Crystal River Nuclear Plant  
Docket No. 50-302  
Operating License No. DPR-72

September 13, 2007  
3F0907-06

Subject: Crystal River Unit 3 – License Amendment Request (LAR) #296, Revision 1:  
Measurement Uncertainty Recapture Uprate Response to Request for Additional  
Information (TAC No. MD5500)

Case #: CR-992-3P-BF

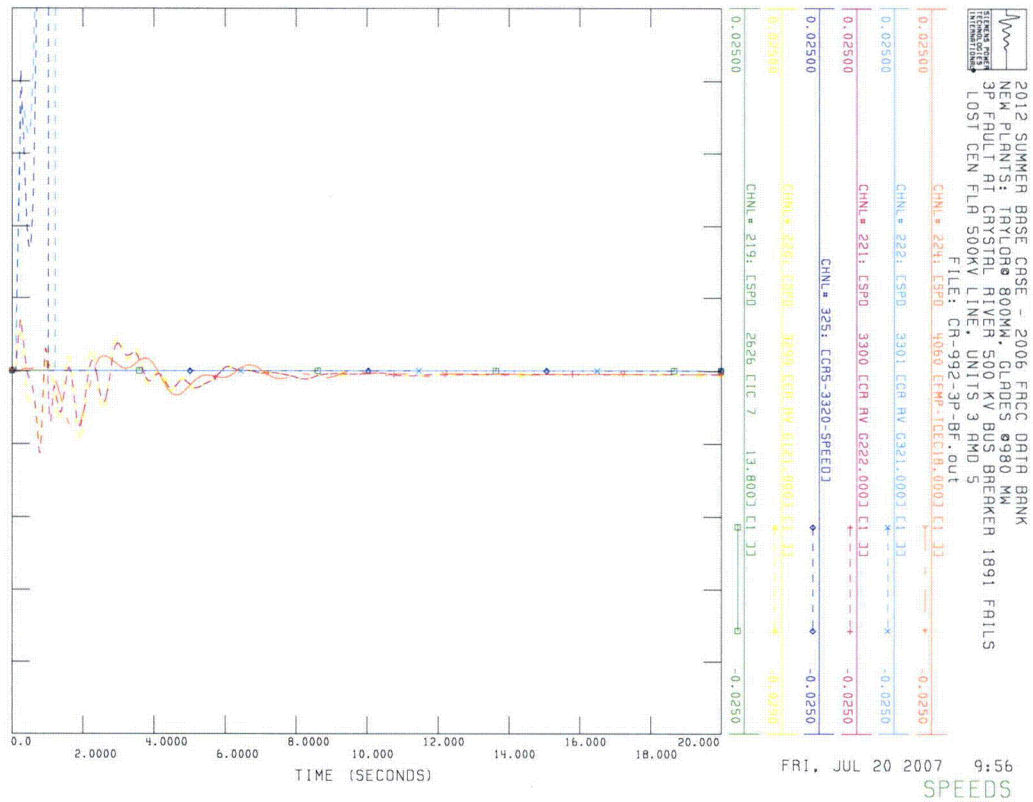
- 5. In Attachment D, section 5.2.4., "Grid Stability" of the submittal dated June 28, 2007, the licensee concludes that an increase in capacity will not have an adverse effect on the grid. Provide a more detailed discussion and/or supporting evidence for the factors or criteria considered for the above conclusion.**

Disturbance: Three phase fault at the Crystal River 500 kV with breaker failure  
(Bkr. 1891)

Comments: 1529 MW generation lost.  
Post transient power flow analysis shows no voltage or loading  
problems.
